Item Name: Crosstube Turning Detail

DART AEROSPACE LTD	Work Order:	101362
Description: Crosstube Assembly (205/212/412 High Fwd)	Part Number:	D212-664-141
Inspection Dwg: D212-664-141 Rev: D		Page 1 of 2

DRAWING NO. D212-664-141	TITLE XTUBE ASSY (205/212/412 HI FWD)	REV. D	DART AEROSPACE LTD ENGINEERING ORDER		D.E.O. NO. D212-664-141-D-1	SHEET NO. SHEET 1 OF 2	SCALE NTS
DRAWN	CHECKED <i>UP</i>	MFG. APPR. <i>ER</i>	APPROVED <i>MP</i>	DE APPR. <i>MP</i>			
DATE 11.04.07	DATE 11.07.11	DATE 11.04.12	DATE 11/04/12	DATE 11.04.12

**D212-664-141/-141B
ASSEMBLY DETAIL**

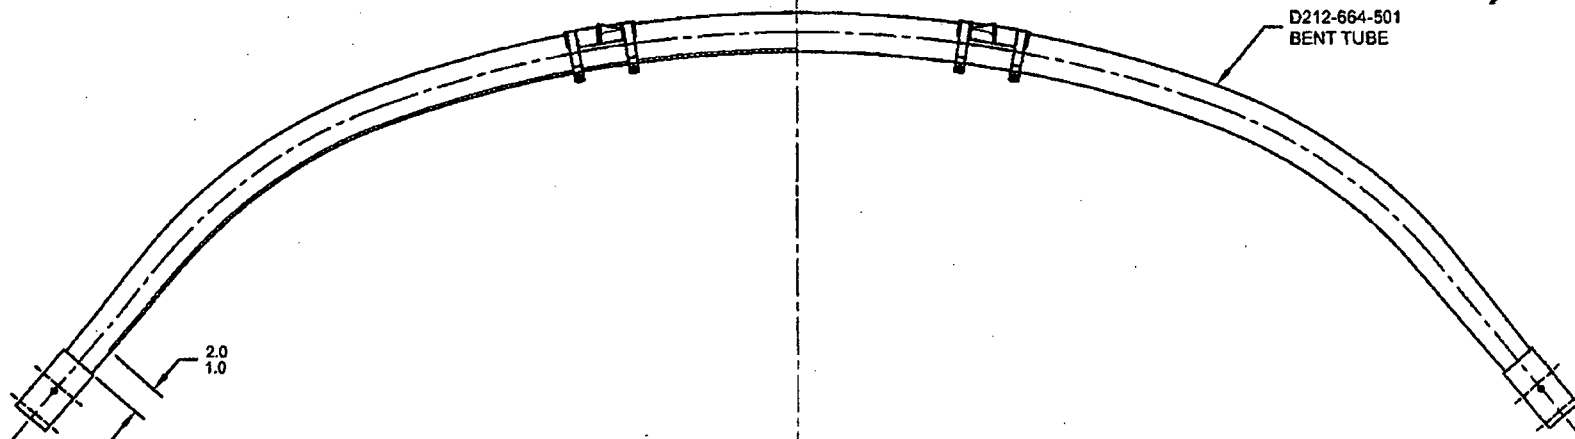
PURPOSE:

ADD AN INSPECTION WINDOW TO UNDERSIDE OF CROSSTUBE.

NOTES 2 OF SHEET 1 IS AMENDED AS FOLLOWS:

- 2) FINISH: CHEMICAL CONVERSION COAT PER DART QSI 005 4.1
PRIME INSIDE AND OUTSIDE PER DART QSI 005 4.2
MASK UNDERSIDE OF CROSSTUBE AS SHOWN (HATCHED AREA) AND
PAINT OUTSIDE PER DART QSI 005 4.2
REMOVE MASKING AND APPLY CLEAR COAT

- 2) FINISH: CHEMICAL CONVERSION COAT PER DART QSI 005 4.1
PRIME INSIDE AND OUTSIDE PER DART QSI 005 4.2
PAINT OUTSIDE PER DART QSI 005 4.2

MASK AREA PRIOR TO PAINTING.
REMOVE MASKING AFTER PAINT
AND APPLY CLEAR COAT
